Re: Structural Observation — 62 Angel Oak Drive, Bunnlevel, NC 28323

At your request, on February 3, 2022 we performed a review of the structural plan proposed by *Tarheel Basement Systems* for the foundation stabilization work at the Bunnlevel residence noted above. The structure is a conventionally framed, detached, single family residence with raised first floor framing over a pier/girder foundation system with perimeter masonry foundation walls (*see picture 1*).

Repair schematic

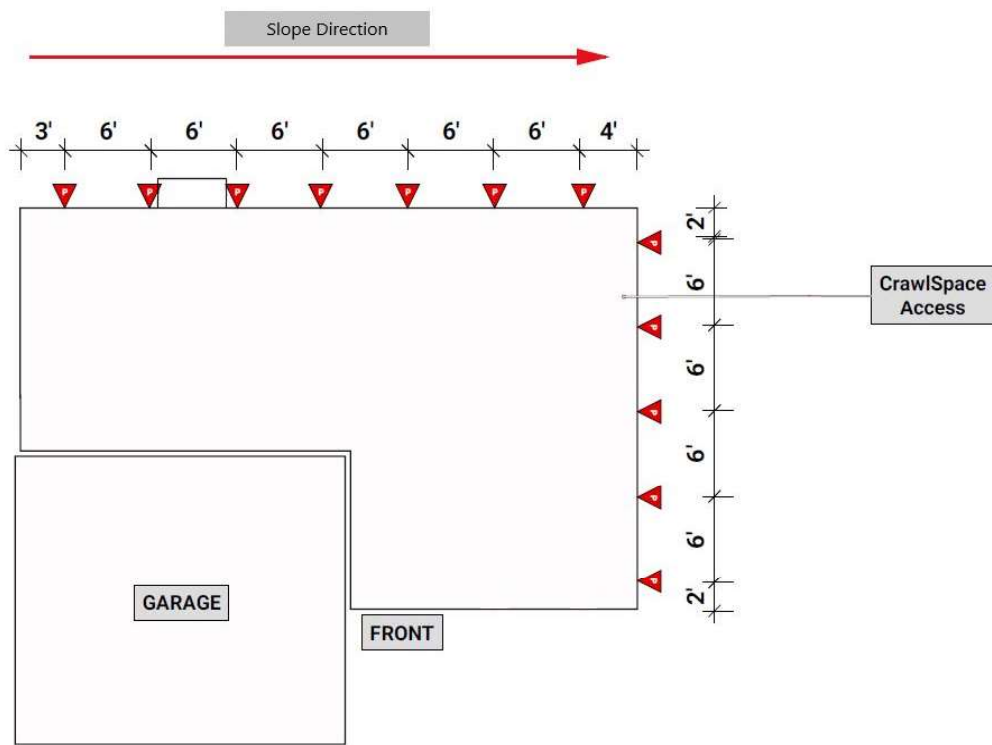
- Avoid installing piers under windows and doors
- Install piers at approximately 6' on center and at the approximate locations shown in the attached repair schematic.
